Re: Petition No. Petition 1226 - Towantic Switch Station and Line Project

Response to CSC-01 Interrogatories dated 04/28/2016

**CL&P dba Eversource Energy**  
**Petition No. Petition 1226**

WATERBURY, MIDDLEBURY, & OXFORD, CT  
PAGE 9 OF 26

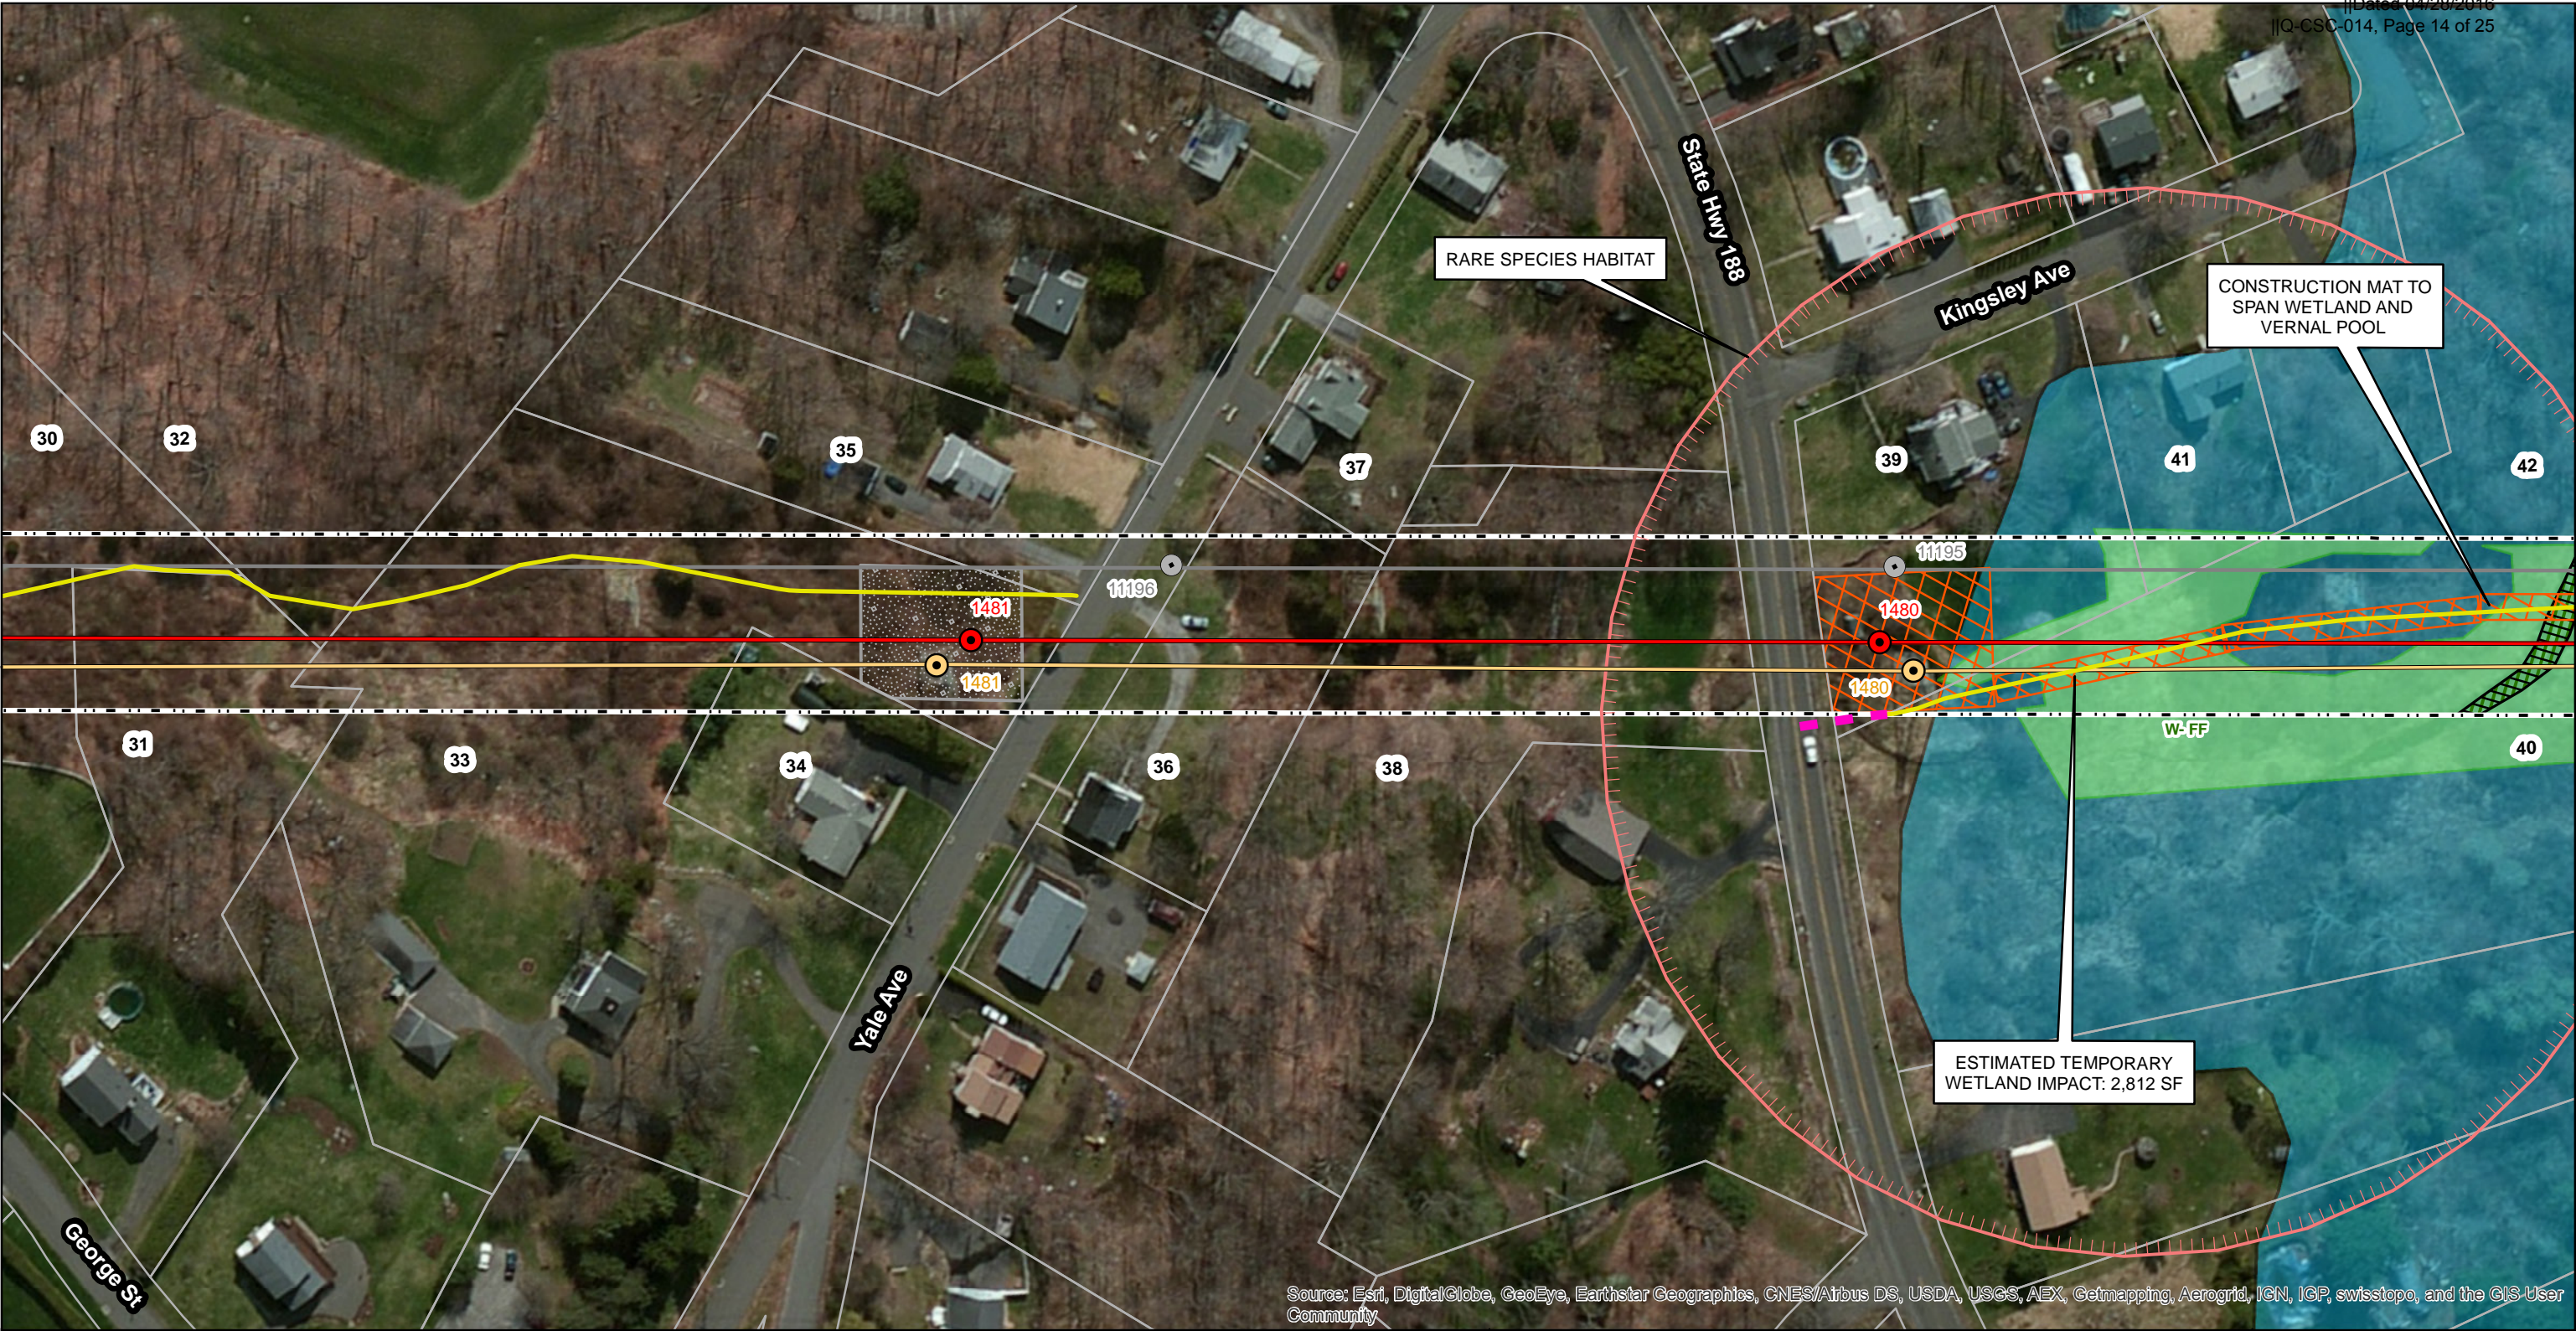
Provide a detailed vernal pool analysis consistent with Calhoun and Klemens (2002) Best Development Practices for the existing vernal pools in the vicinity of the proposed project. Could construction be performed outside of the active breeding season for vernal pool species?

Work associated with structures 1479 through 1483 (mapheets 9, 10 and 11), which occurs within or near two of the three vernal pools (FF and GG) will be conducted outside of the breeding season for the vernal pool species, which is March through July. The only work conducted within or near vernal pools during the breeding season will be the reconductoring of Structure 1447 within the vernal pool of Wetland L. This is unavoidable because that work needs to be done during the scheduled outage period of February, 27, 2017 to June 15, 2017. However, as noted in the petition and on mapheet 25, this work will be done manually with no vehicles allowed in the resource area and would deploy vernal pool BMPs to protect the pools' integrity.

- Work associated with structures 1479 through 1483 (Sheets 9, 10 and 11) which occurs within or near two of the three vernal pools in the project area (FF and GG) will be conducted outside of the breeding season for vernal pool species which is March thru July.

WATERBURY, MIDDLEBURY, & OXFORD, CT  
PAGE 10 OF 26

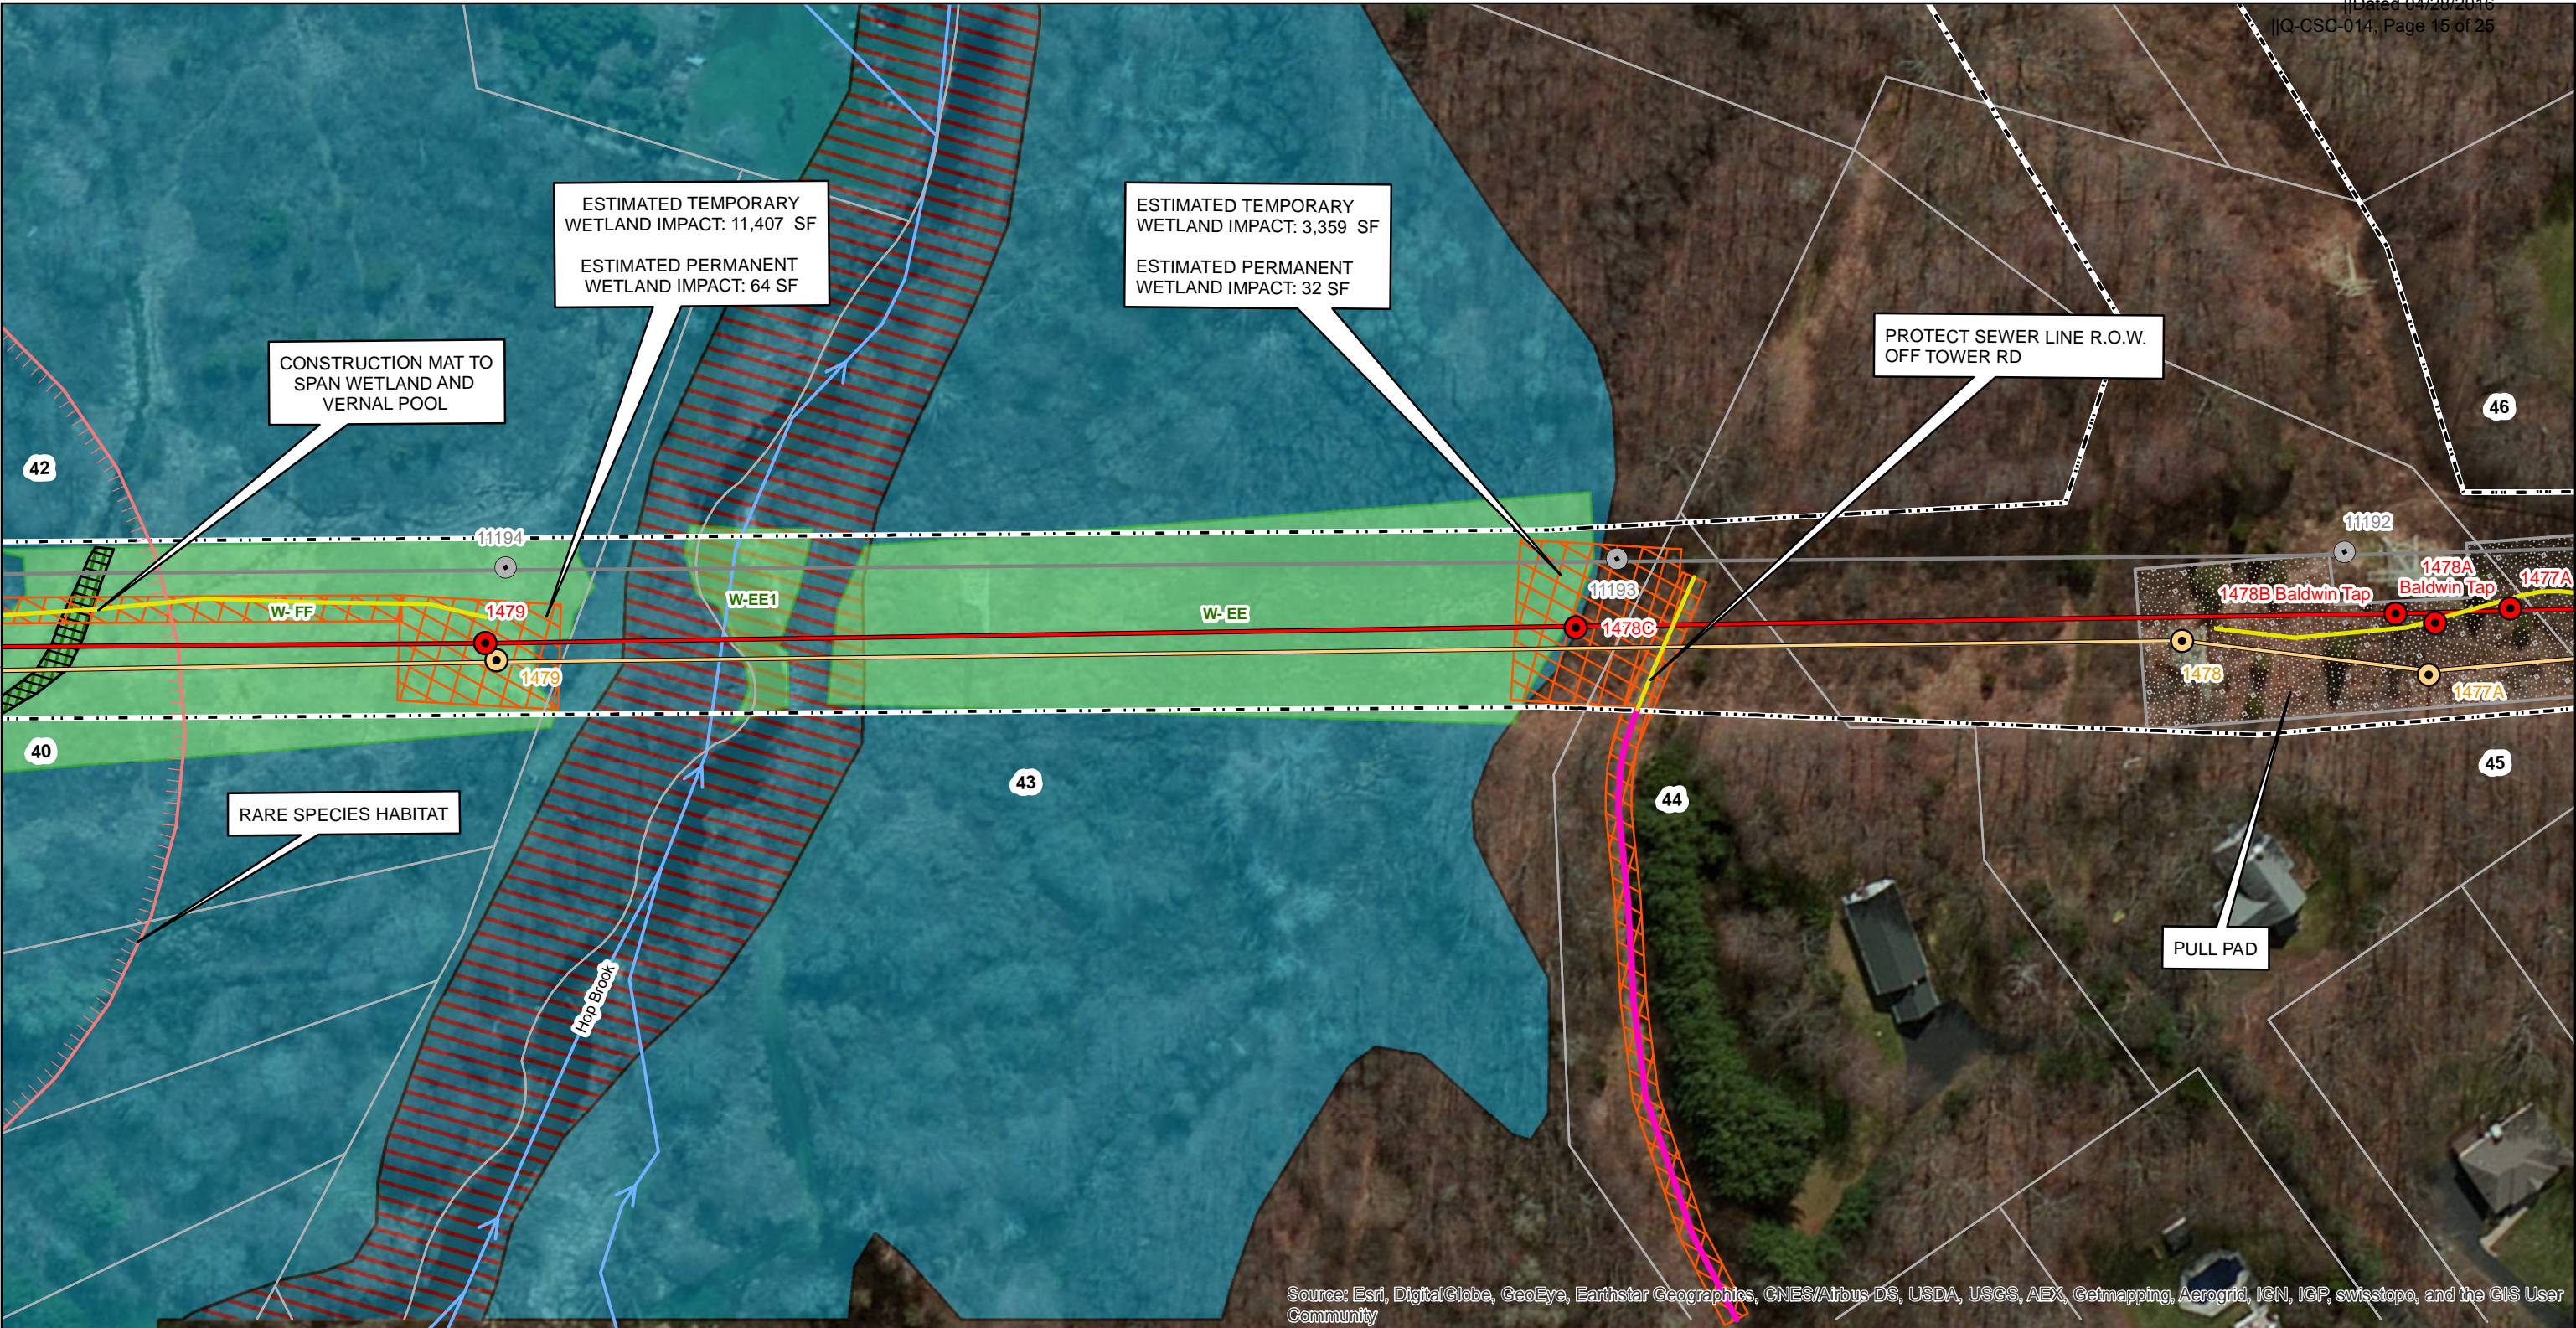
On Sheets 10 and 11, would the proposed “Construction Mat to Span Wetland and Vernal Pool” create any permanent adverse impacts to the vernal pool?

The Project does not anticipate any permanent adverse impacts to the vernal pool located within Wetland FF, as depicted on map sheets 10 and 11. Temporary crossing of this vernal pool will be at a narrow point of the pool (see photo below) which is approximately 8 feet wide. A single construction mat will completely span this resource and will be removed immediately after work is completed in this area.

- Temporary crossing of the vernal pool within Wetland FF will be done at a narrow point of the pool, therefore a single construction mat will be installed to completely span the vernal pool. The construction mats will be removed immediately after work is completed in this area.

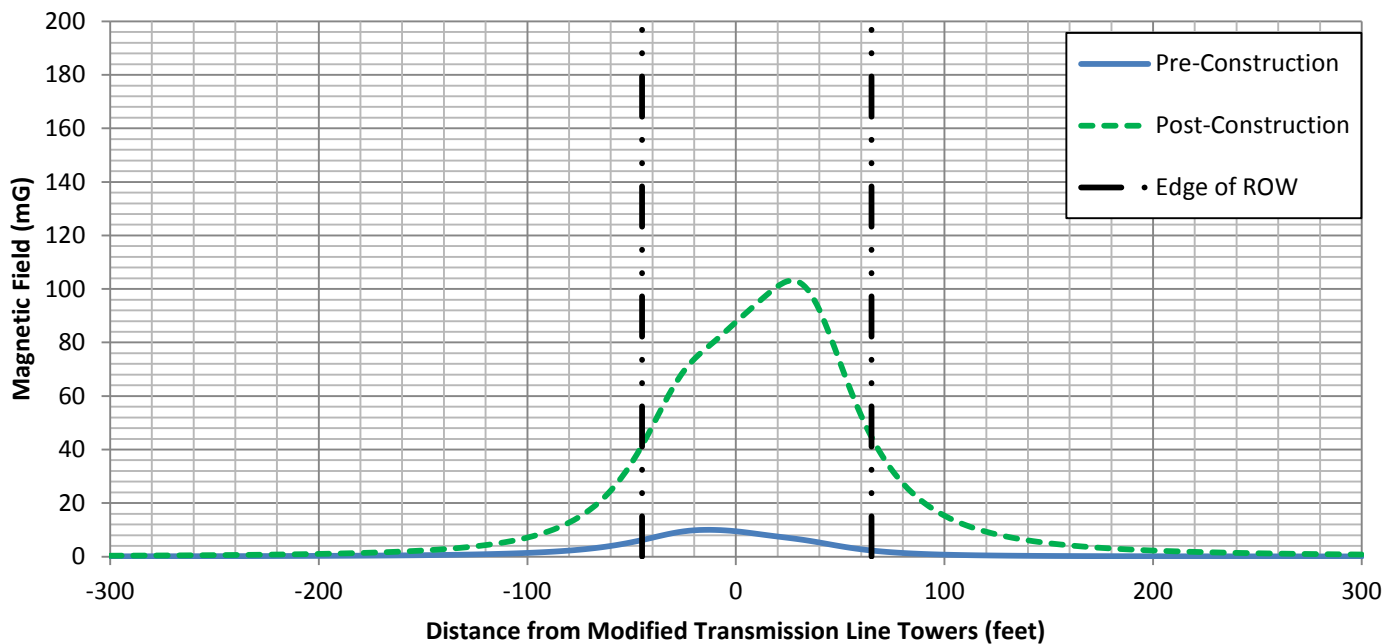
On page D-18 of the Petition, Eversource notes that, "Calculations of EMF were not performed for the reconductoring portion of the Project, between Towantic Switching Station and Oxford Substation, as no change to the electric field at the edges of the ROW will occur as result of the Project." How would magnetic fields change from pre-construction to post-construction at the eastern and western edges of the ROW for the reconductoring portion of the project? While the line geometry/configuration would be very similar, would the change in magnetic fields, if applicable, be due to changing power flows due to the power plant?

Yes, the power flows, and therefore magnetic fields, would change as a result of introducing an operating generator onto the system. The calculations are attached. The calculations based on these assumptions are attached and assume an average annual load with a typical generator dispatch including 765 megawatts of output from the CPV Towantic generating station.
